INTRODUCTION

OUTLINE OF NEW FEATURES

The following changes are made for the new FJ Cruiser.

2. Exterior

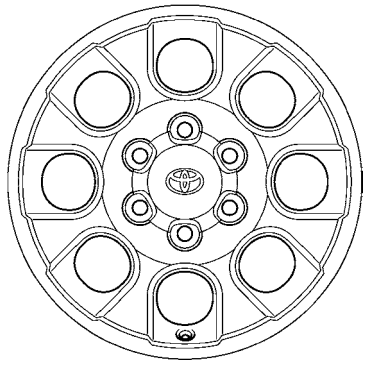
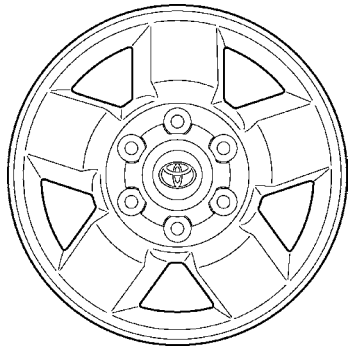
The following exterior colors have been provided.

▶ Layout example of indicator and warning lights ◀

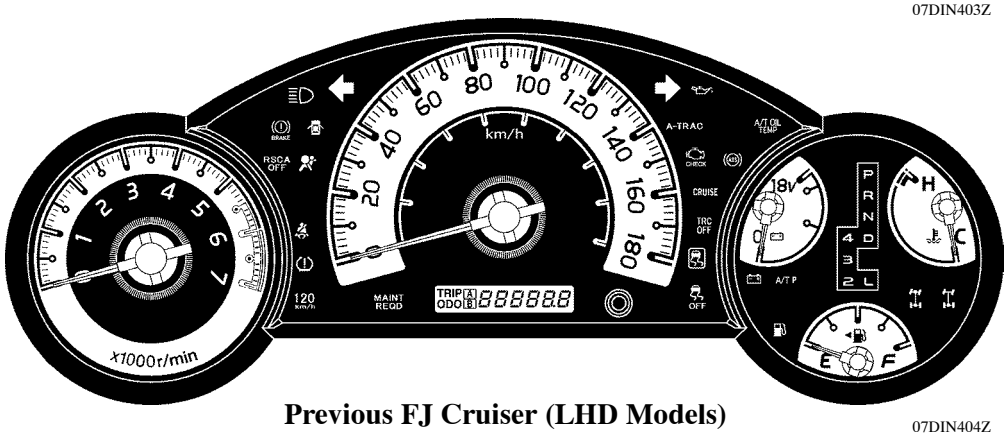
- The location of all indicator lights has been changed.
